Access Compliance Report

Public Rights-of-Way

(Curb Ramps)

Intersection ID: 24214	Main Street: HENSEY'S_WY	Cross Street: BEVERLY_CREST_BV	Location: E
ADA ID: 86CA7F9BE33B	Ramp Type: Perp	Initial Pass/Fail: Fail	Overall Compliance: No
Codes/Mitigation Info/Possible Solution		Field Measurements/Component Compliance	
Severity Score: 13.75

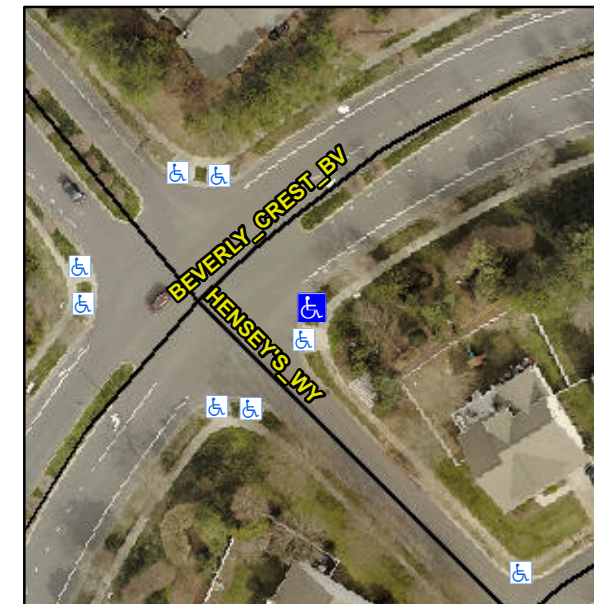
Not Found, R304.2.2, R304.5.3

Compliance	Description	Data	Compliance	Description	Data
N/A	Ramp Length (in)	100.0	No	Ramp Slope (%)	9.2
Yes	Ramp Width (in)	68.0	No	Ramp XSlope (%)	3.5
N/A	Flare Type LT	N/A	N/A	Flare Type RT	N/A
N/A	Flare Slope LT (%)	N/A	N/A	Flare Slope RT (%)	N/A
N/A	Flare Traversable LT?	N/A	N/A	Flare Traversable RT?	N/A
N/A	Landing Length (in)	N/A	N/A	DWS Provided?	N/A
N/A	Landing Width (in)	N/A	N/A	DWS Contrast?	N/A
N/A	Landing Slope (%)	N/A	N/A	DWS Length (in)	N/A
N/A	Landing X Slope (%)	N/A	N/A	DWS Full Width?	N/A
N/A	Landing Curb? (Y/N)	N/A	N/A	DWS Offset (in)	N/A
N/A	Shared Landing?	N/A			
N/A	Gutter Ponding?	N/A	N/A	Gutter Slope (%)	N/A
N/A	Gutter Lip Ht (in)	N/A	N/A	Gutter X Slope (%)	N/A
N/A	Painted X Walk1?	No	N/A	Painted X Walk2?	N/A
	X Walk 1 Direction	To N		X Walk 2 Direction	N/A
N/A	X Walk 1 Width (in)	N/A	N/A	X Walk 2 Width (in)	N/A
	X Walk 1 Slope (%)	3.5		X Walk 2 Slope (%)	N/A
	X Walk 1 X Slope (%)	1.5		X Walk 2 X Slope (%)	N/A

Remove & Replace Entire Ramp.
